## County of Fairfax, Virginia

### STAFF REPORT

#### APPLICATION CSPA 2004-PR-044

**PROPOSAL:** Amend the approved comprehensive sign plan for the Tysons Corner Center to permit revisions to the wayfinding signs, building and garage mounted signs and provide new building mounted signage for a new office building.

ISSUE DATE  
**October 28, 2011**  
SHEET TITLE  
**Sign 64**

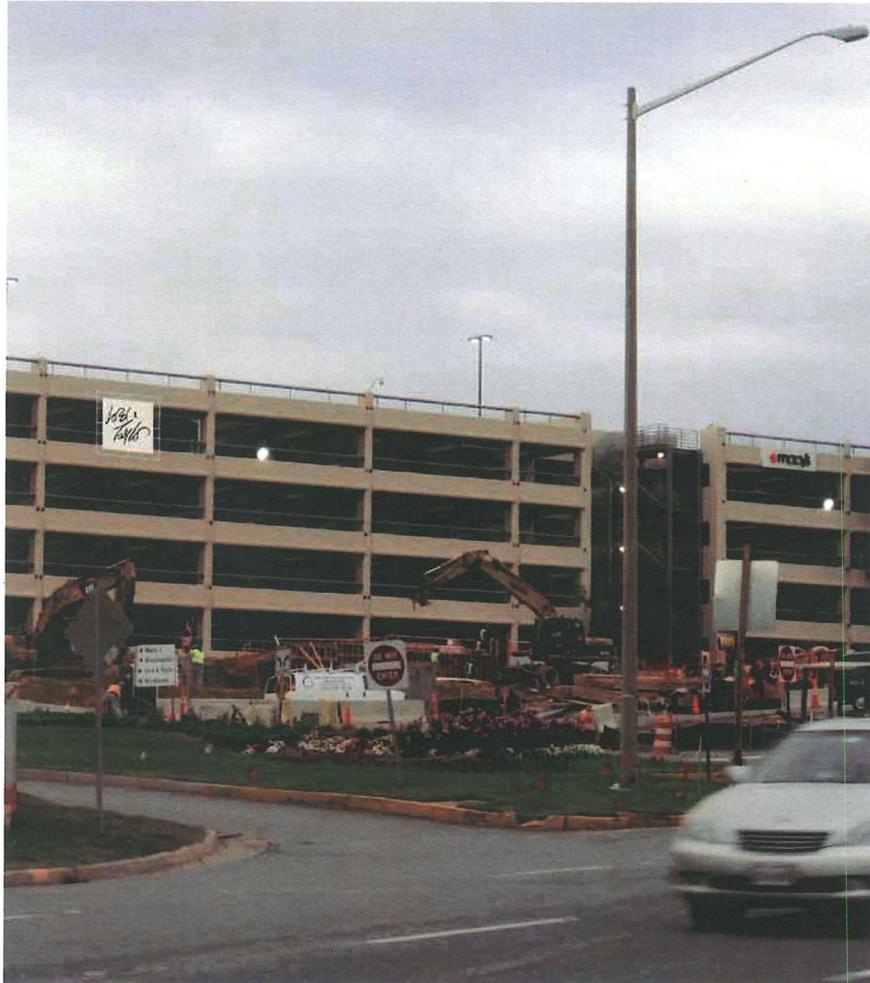
The newly proposed Lord & Taylor sign could be improved by better incorporating the sign element into the architecture of the parking structure. It is understood that a Macy's sign which similar in character currently is installed on this garage; however, the proportions and size of the Lord & Taylor logo and sign appear awkward and unrelated to the design of the structure when applied in this manner. Attached here are three alternatives that illustrate how the sign could be better integrated into the structure.

All three alternatives utilize two layers of screening in a similar manner to that shown on the Parking Terrace E North Elevation (Sheet 10 of the CSP). Alternative A removes the beige background and uses only the letters of the logo on the sign. Alternative B shows the proposed sign that is attached to the screening, and Alternative C shows a larger beige background to the sign, but is more in keeping with the scale of the façade panel. The letters in Alternative C are the same size as currently proposed.

Alternative A

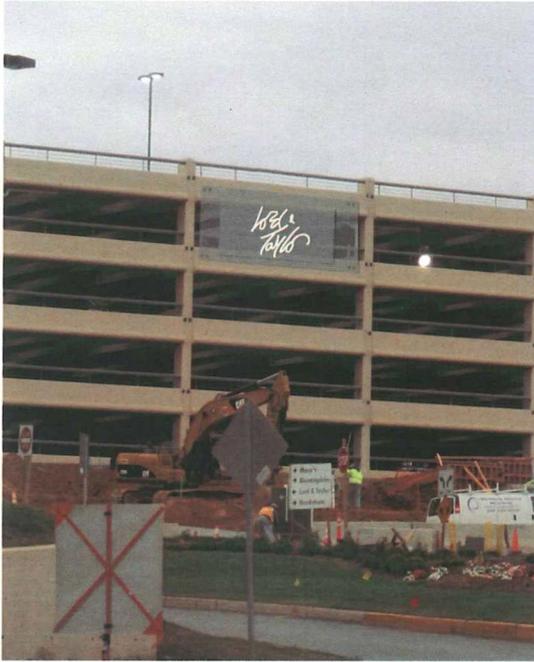
- Two layers of architectural screening similar to the north garage elevation shown on Sheet 10 of the Building Mounted Sign package. Perhaps fastened with architectural elements that mirror the double square details that exist on the parking deck façade.
- Use only the letters from the Lord & Taylor logo.
- Text is slightly larger than that currently proposed
